**TOWN OF MOUNTAIN VILLAGE  
REGULAR DESIGN REVIEW BOARD MEETING AGENDA  
THURSDAY FEBRUARY 1, 2024, 10:00 AM  
MOUNTAIN VILLAGE TOWN HALL  
455 MOUNTAIN VILLAGE BLVD, MOUNTAIN VILLAGE, COLORADO  
TO BE HELD HYBRID THROUGH ZOOM:  
<https://us06web.zoom.us/j/86027664518>  
Meeting ID: 860 2766 4518**

**TO:** Mountain Village Design Review Board  
**FROM:** Claire Perez, Planner II  
**FOR:** Design Review Board Public Hearing; February 1, 2023  
**DATE:** January 15, 2023  
**RE:** Staff Memo – Initial Architecture and Site Review (IASR) Lot 1 Unit 1, TBD Eagle Drive.

C3

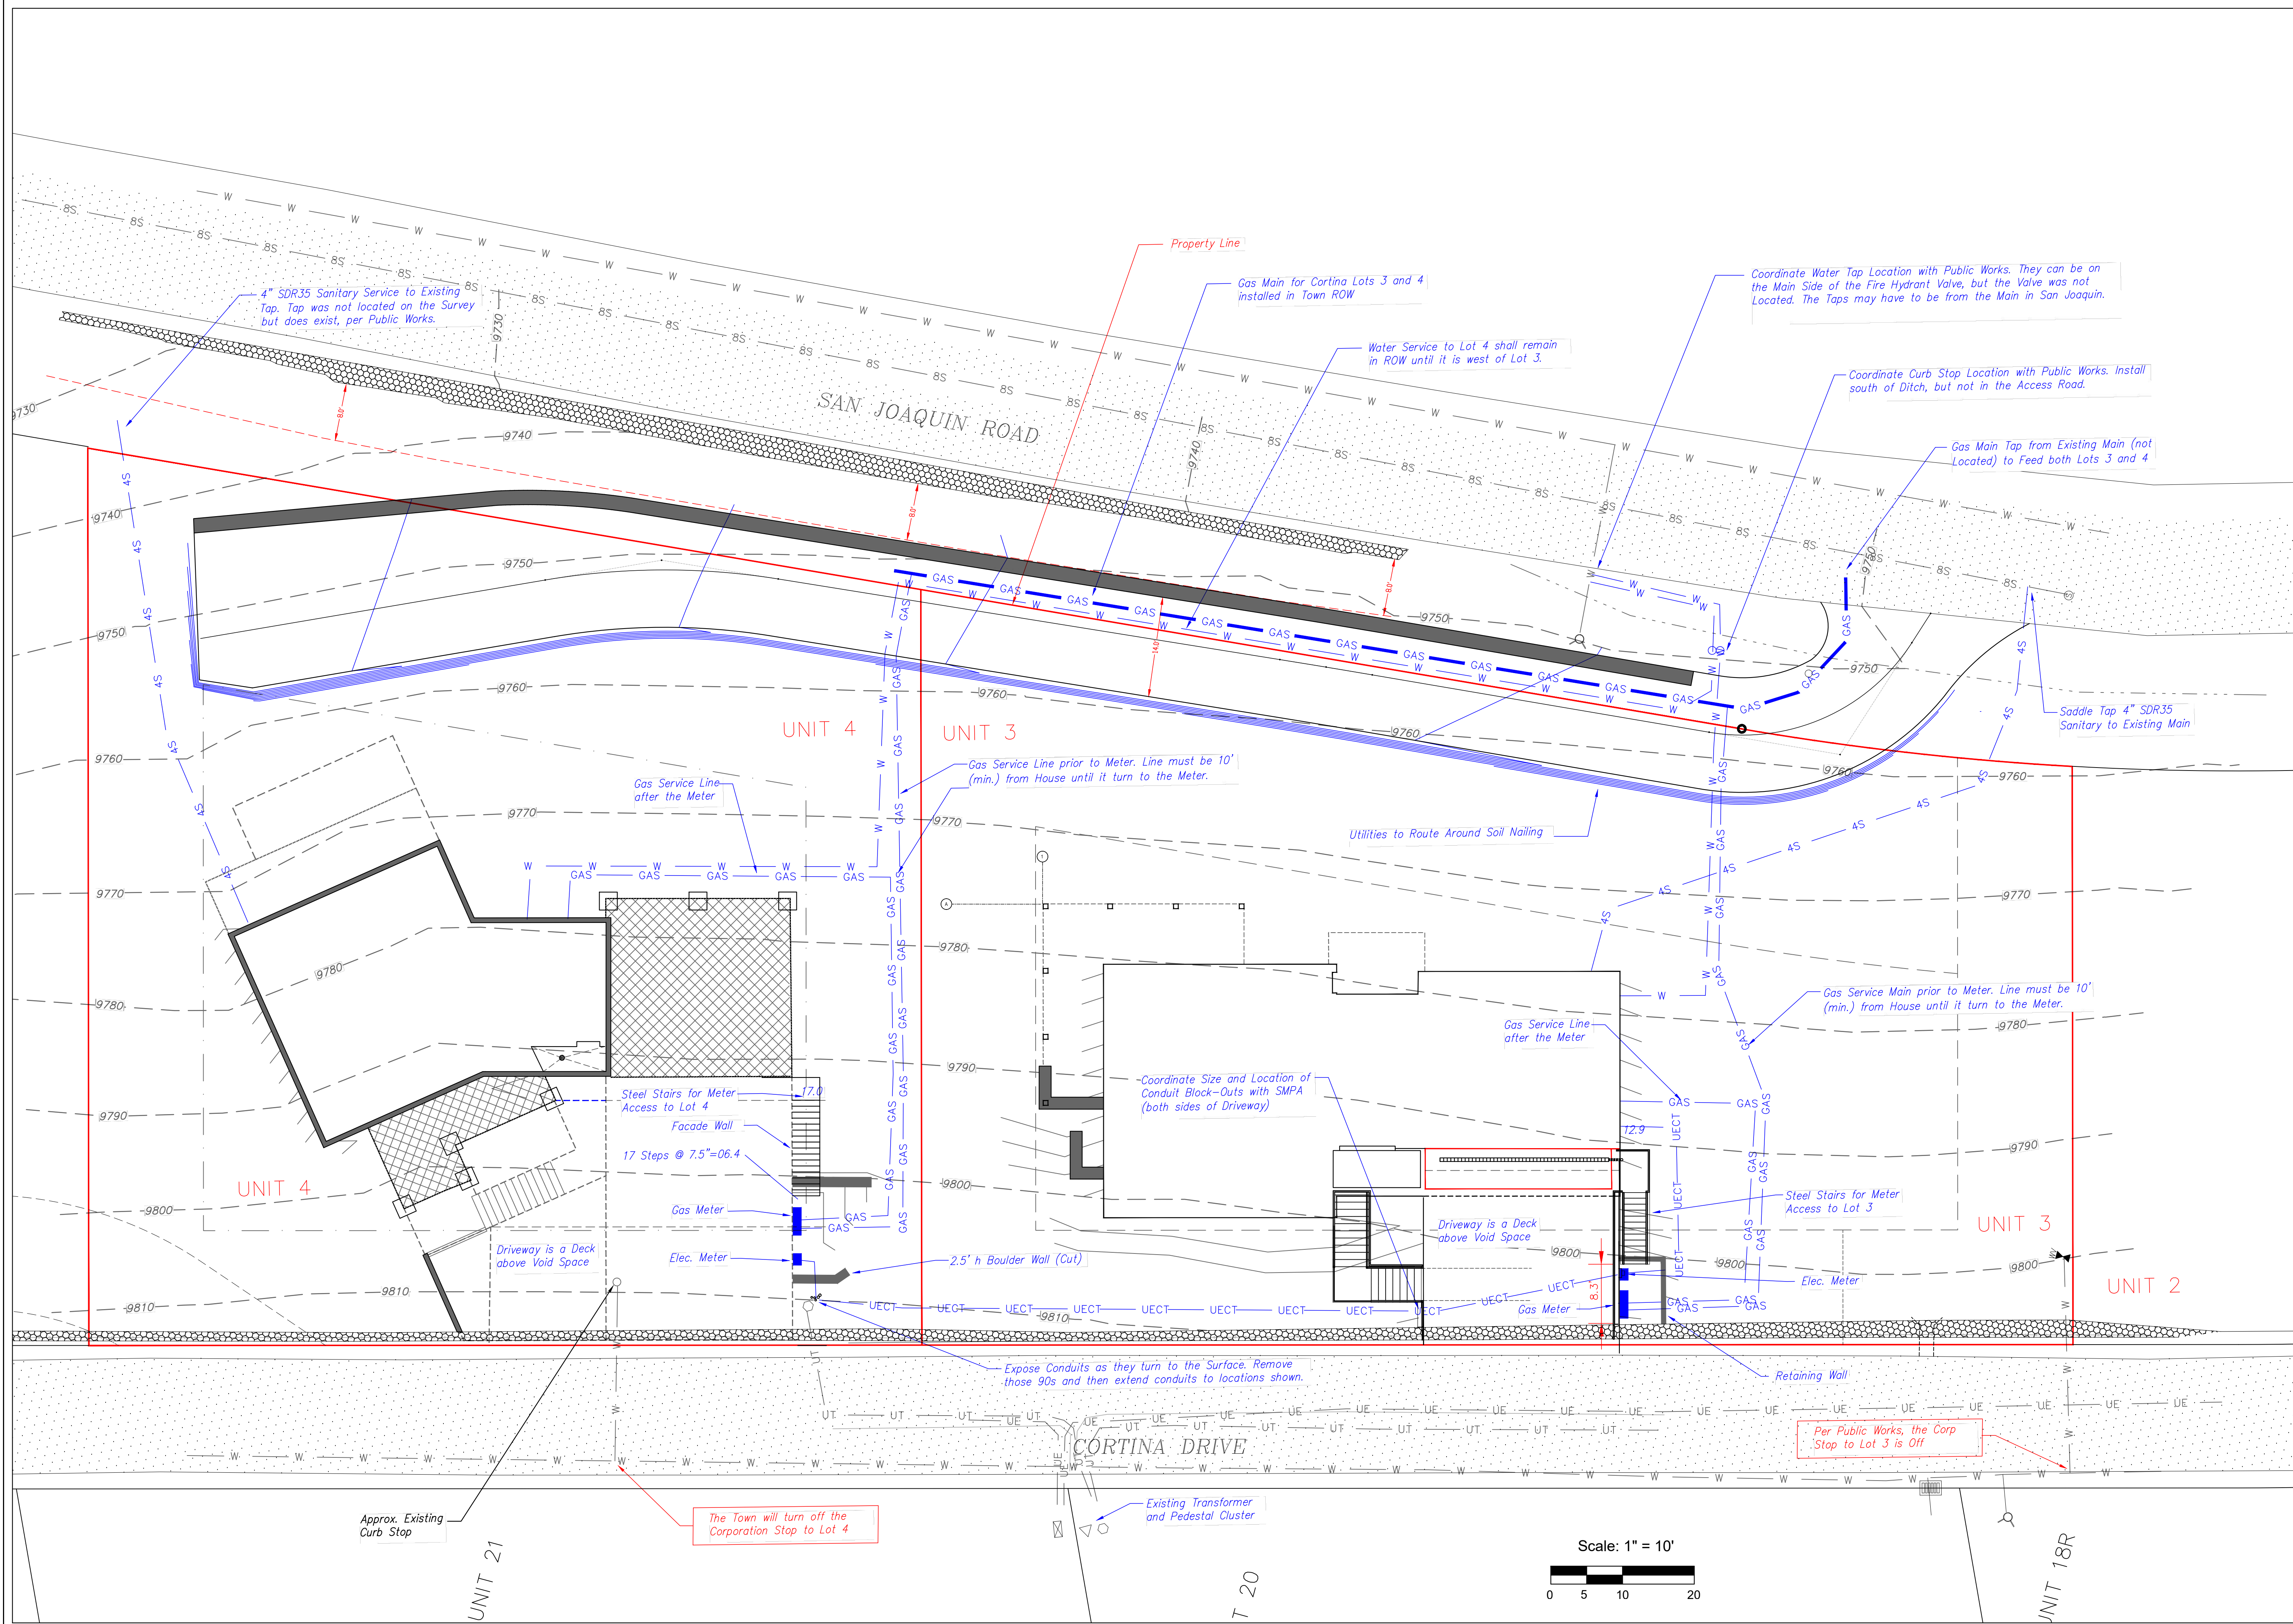
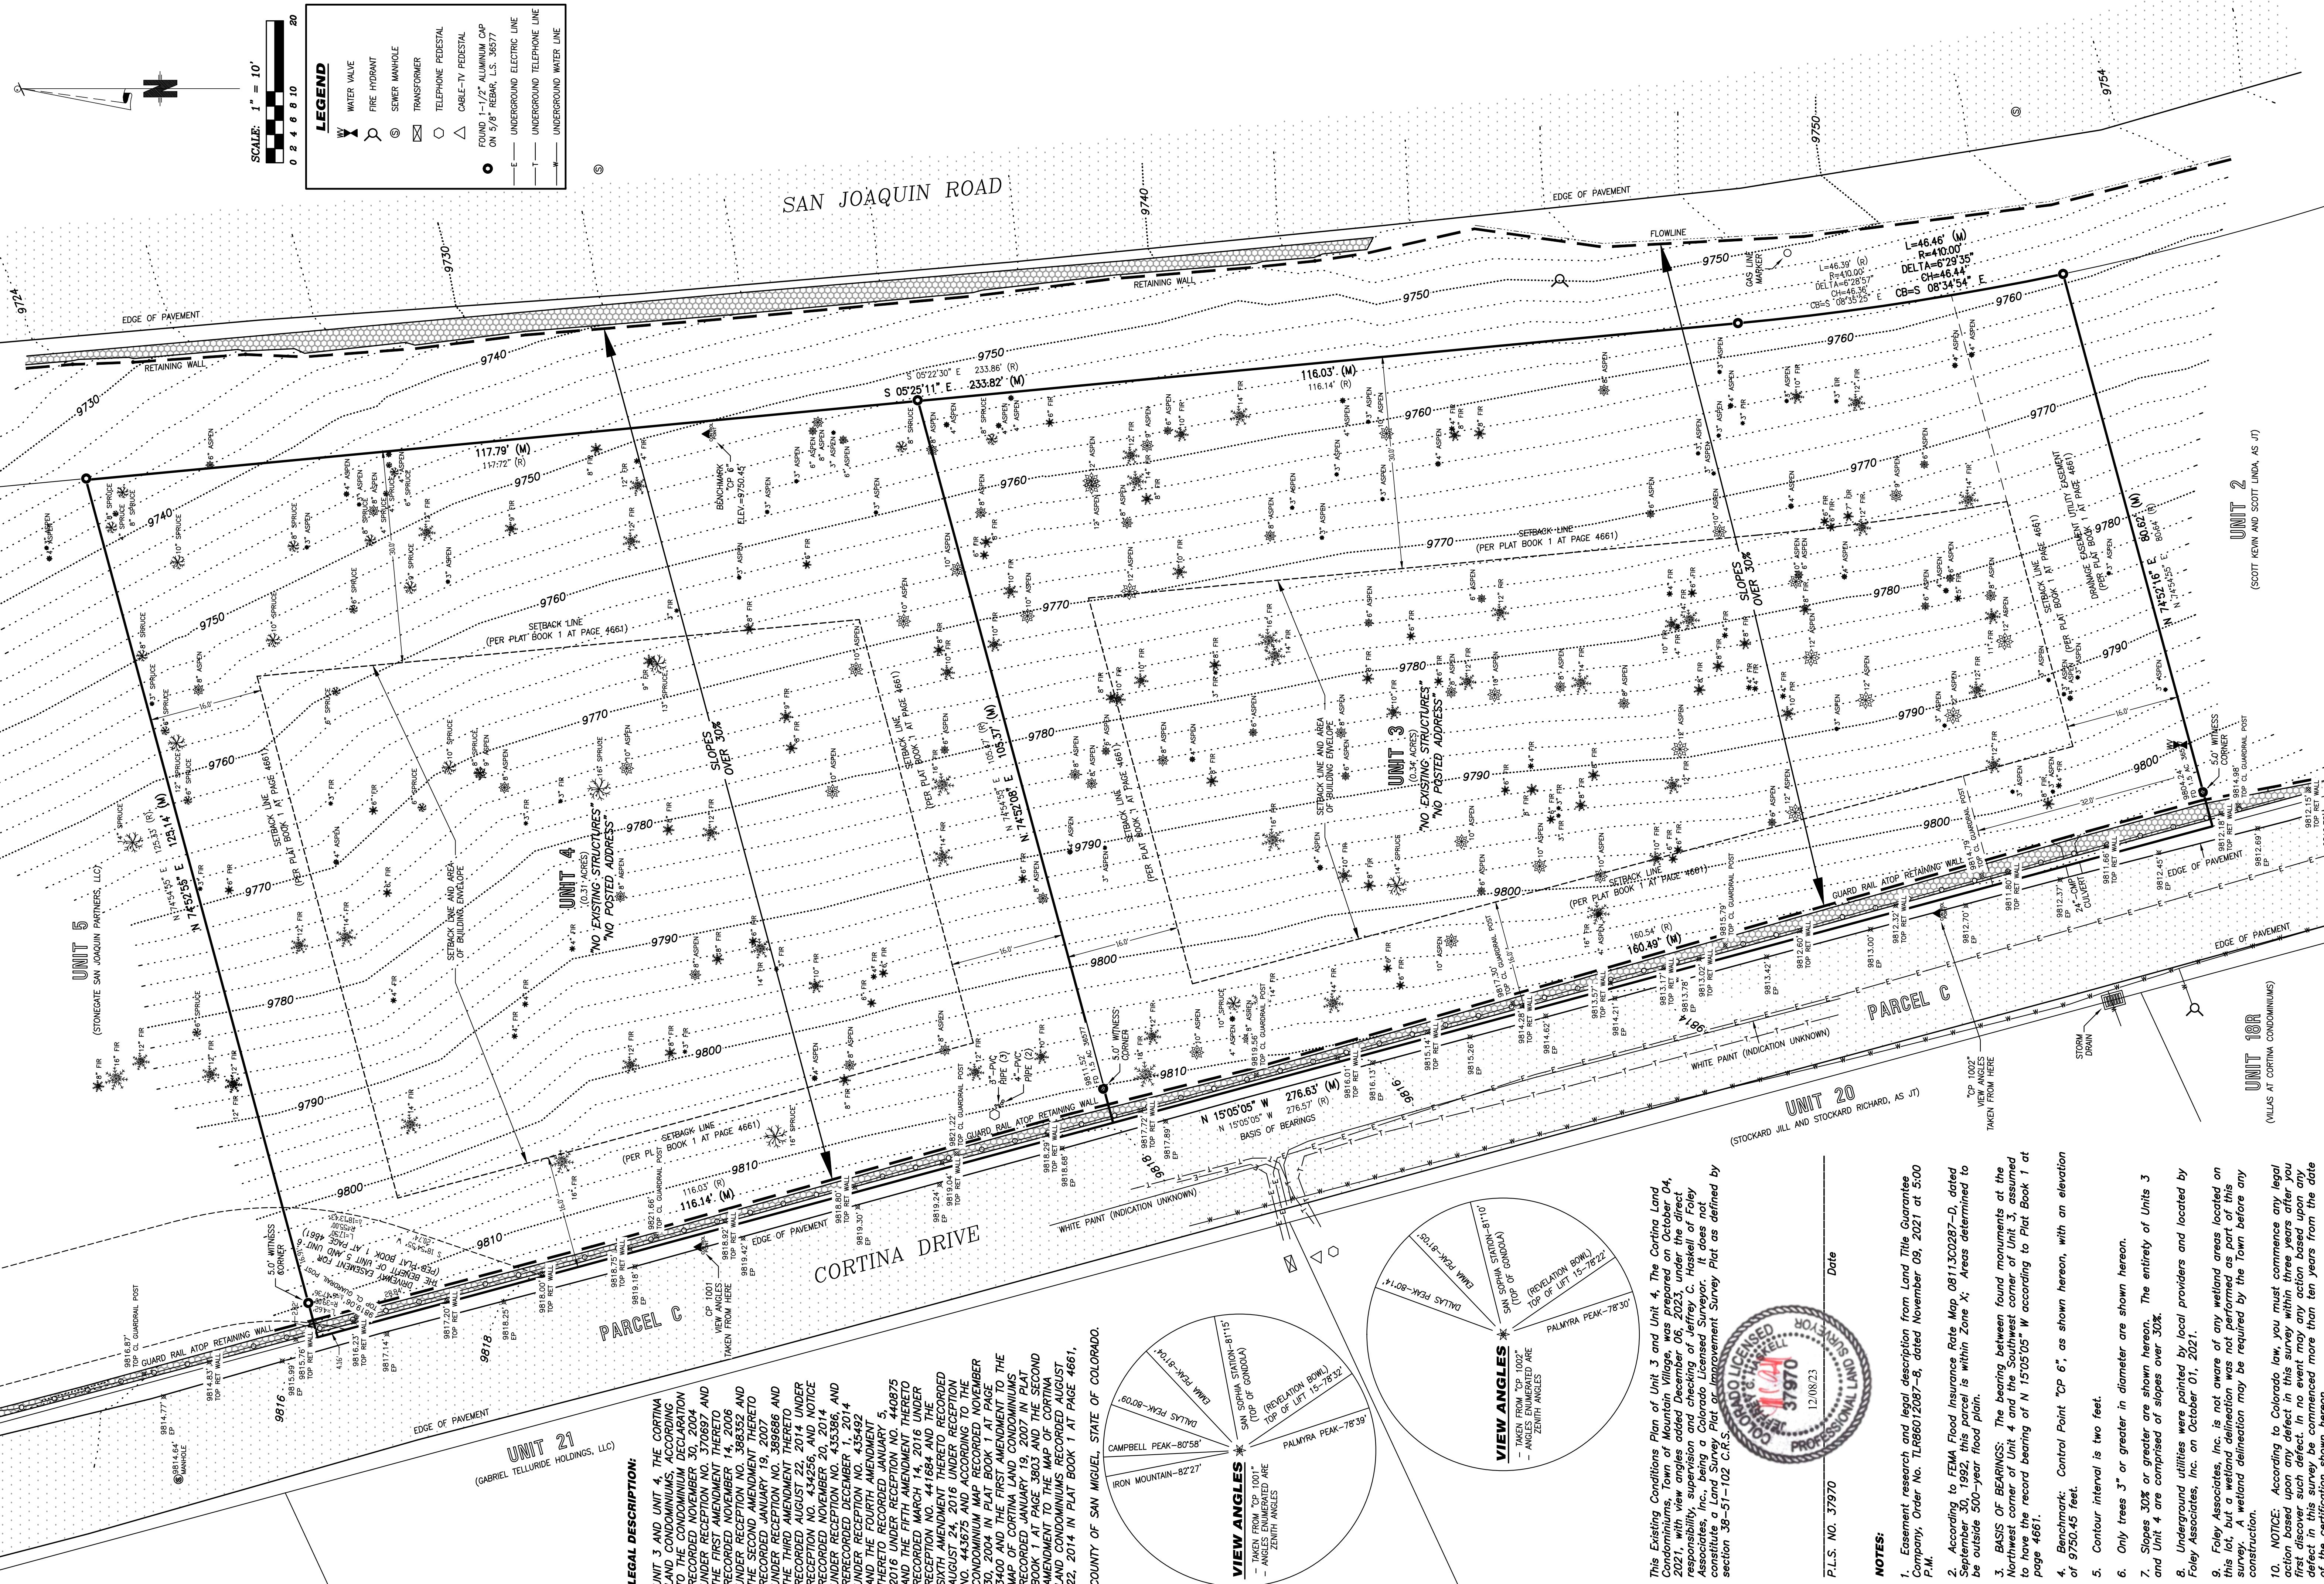
Staff: The applicant has determined that accessing utilities from San Joaquin road is preferable. Utilities are situated around the structure. Gas and water lines are running the south and east side of the property with the gas meter located on the right side of Auto Court. Electric meter is located right beside the gas meter and the line runs on the west side of the property. The utility plan, as presented on sheet C.3 within the submitted documentation, clearly illustrates the locations of these utilities. All utilities traverse the setback area surrounding the residence and comply with the CDC regulations.

**A1.3**

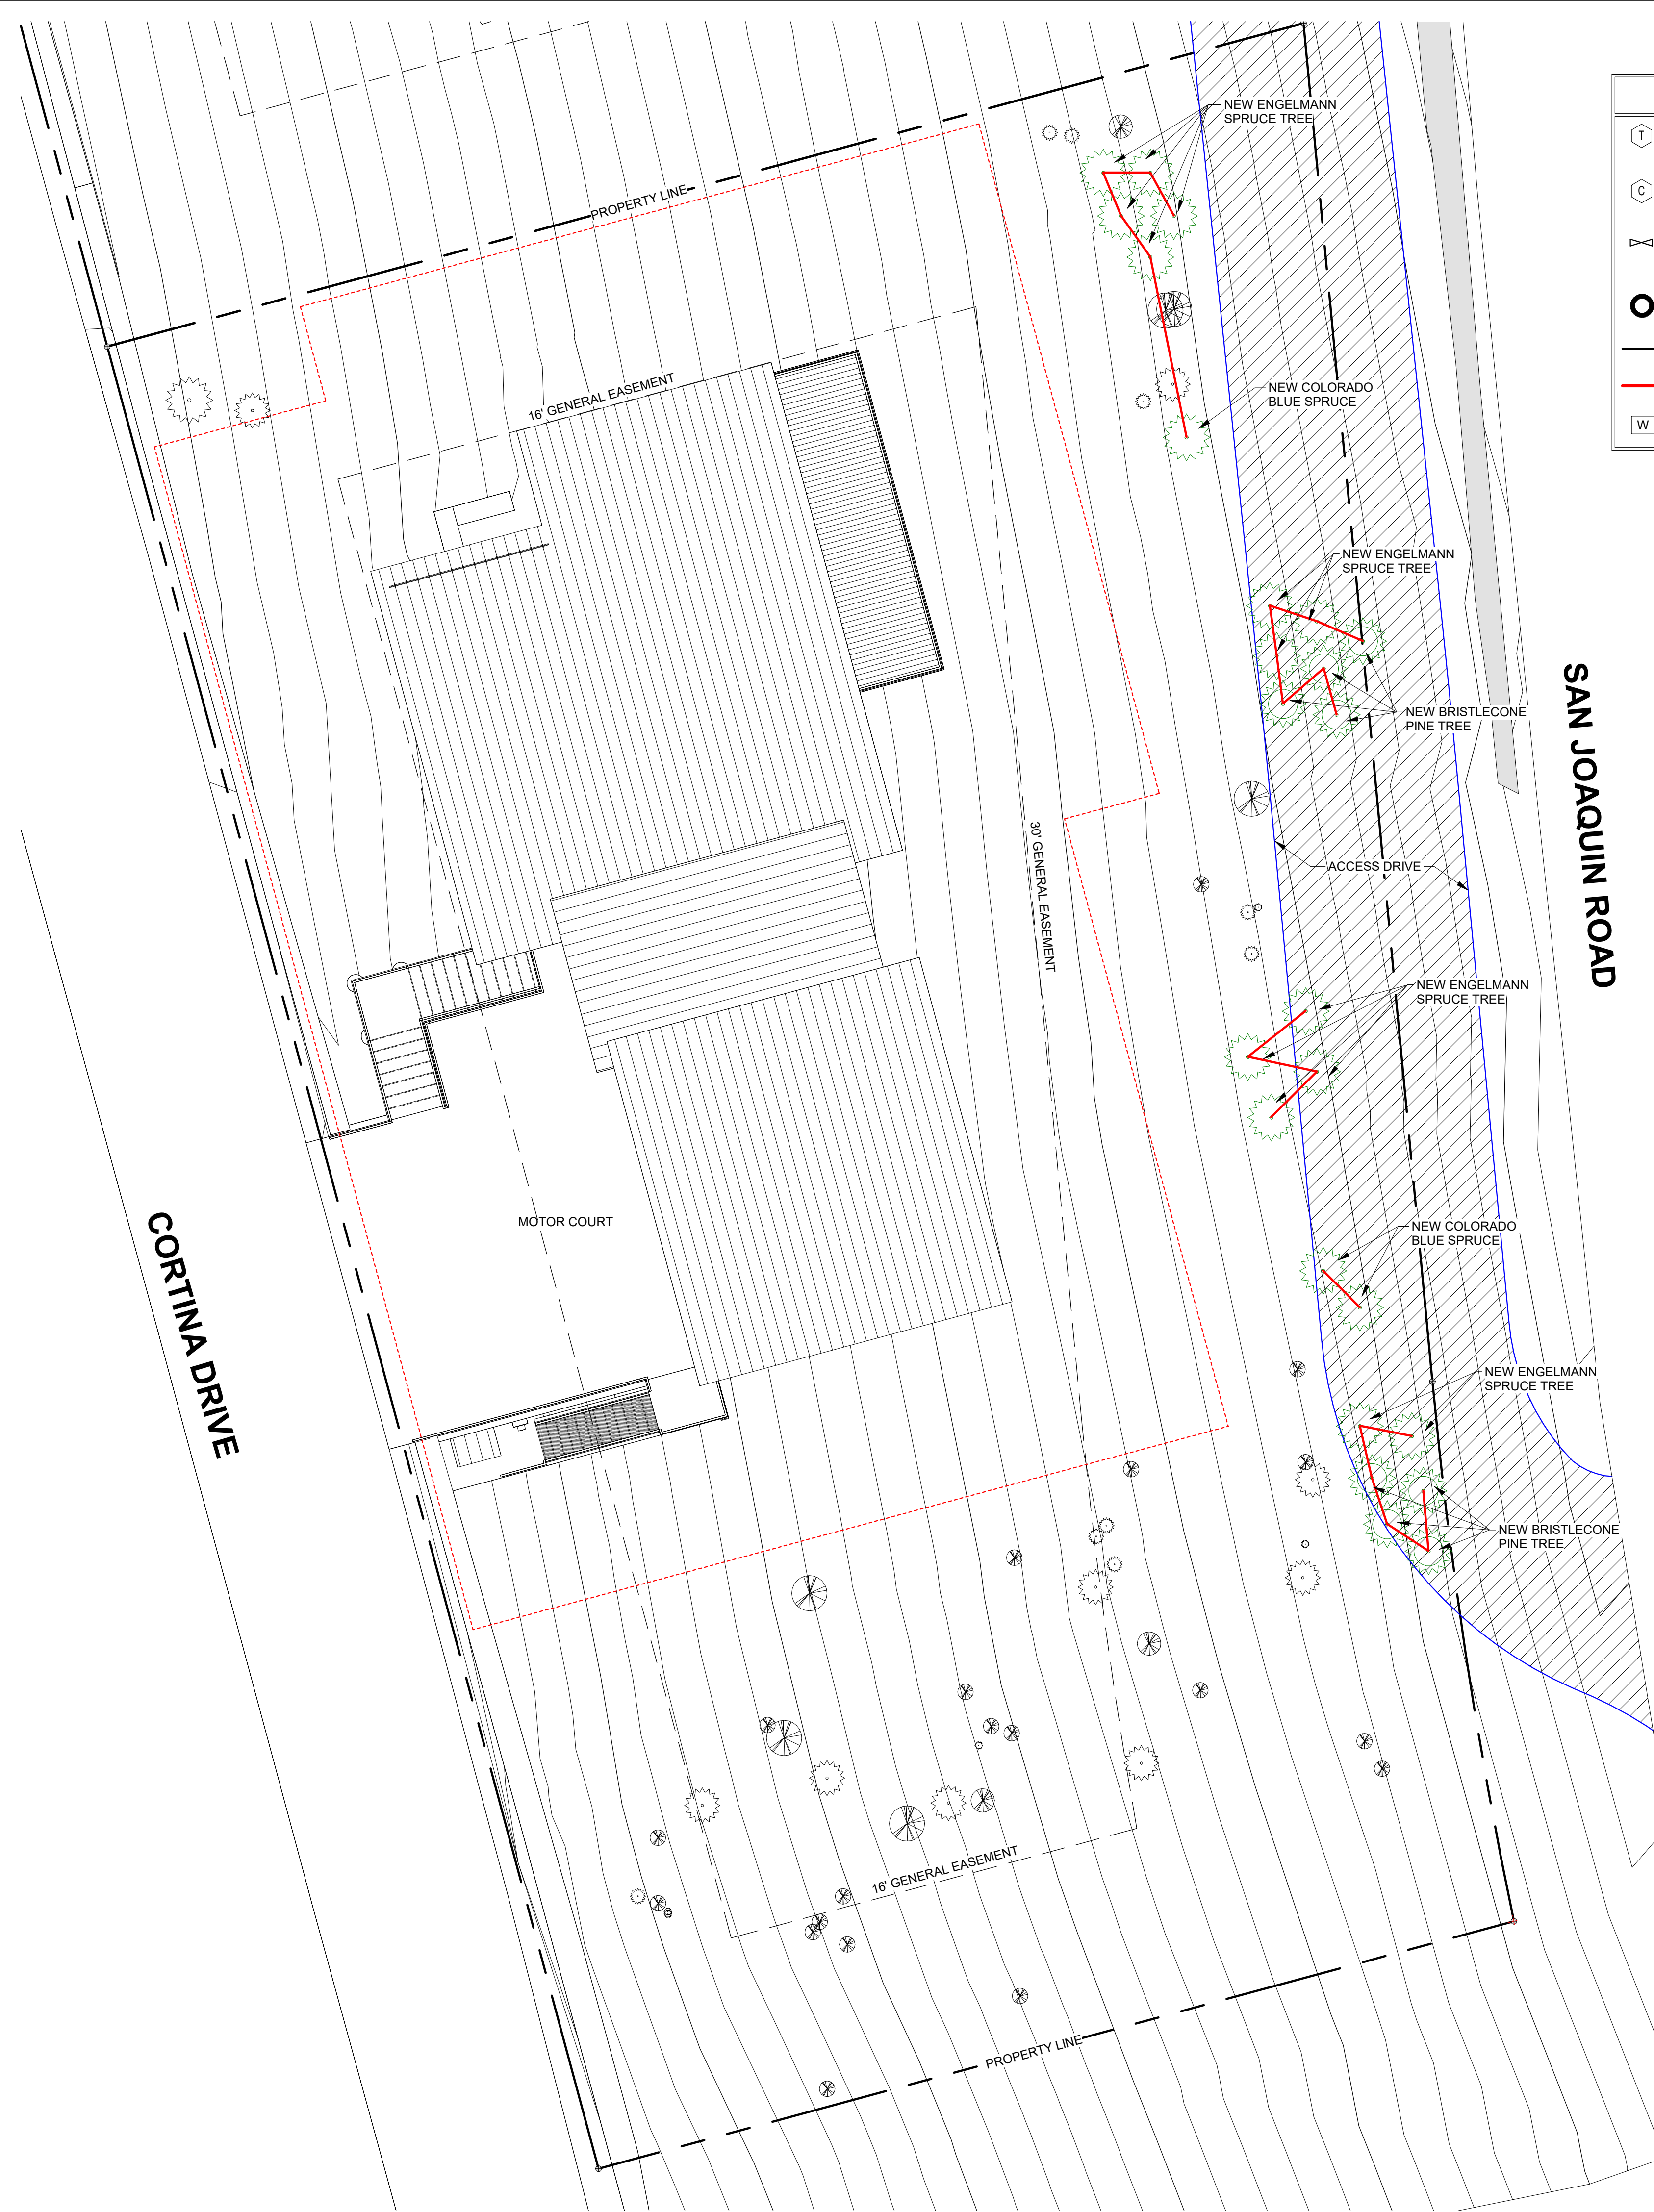
Staff: An initial landscaping plan was provided on sheet A1.3 of Exhibit A. The applicant is proposing the addition of 14 Engelmann Spruce, 3 Colorado Blue Spruce, and 8 Bristlecone Pine along with retaining the existing vegetation outside of the Zone 1 fire mitigation area.
